Committee To End Radiological Hazards

- May 19, 1972 -

Re: Invited Citizens' Comments on the
Environmental Impact of the Proposed
Issuance of an AEC Operating License
to Con-Ed's Indian Pt. Nuclear Reactor
DOCKET NO. 50-21

Location of cancer cases

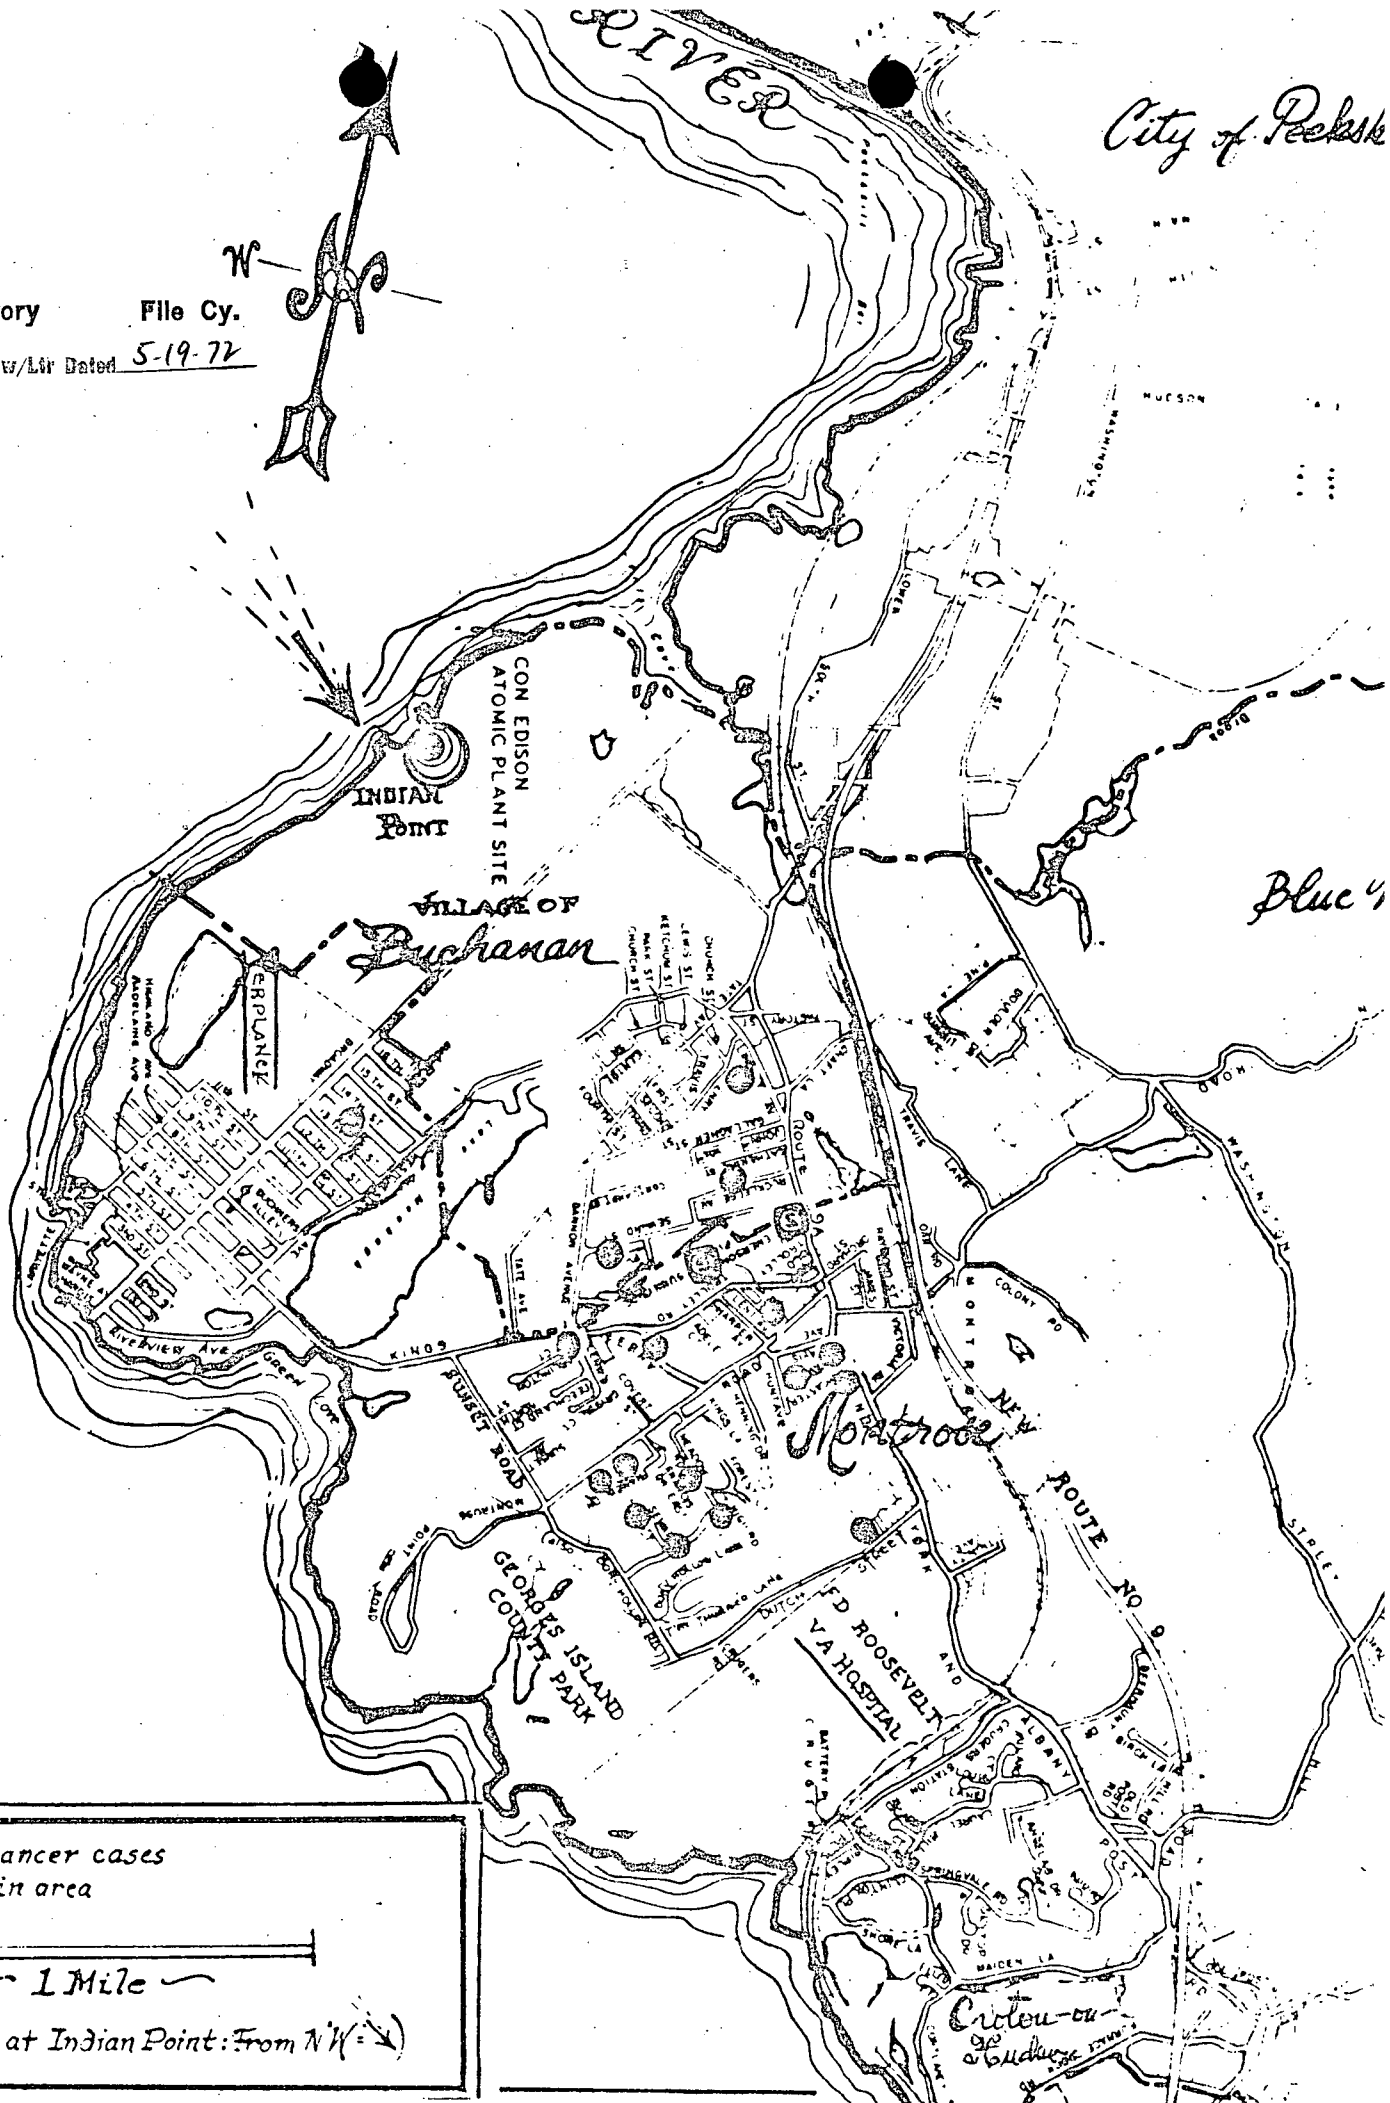
show that 3 out of the 4 brain cancer deaths reported in 1963-67 for this Cortlandt area of 22,000 were actually registered from the Montrose section I described in "The Montrose Catastrophe" - population, less than 500!

* Three of these 4 deaths were recorded for a small section (c. 500 population) of MONTROSE directly downwind to the Indian Point atomic plant.
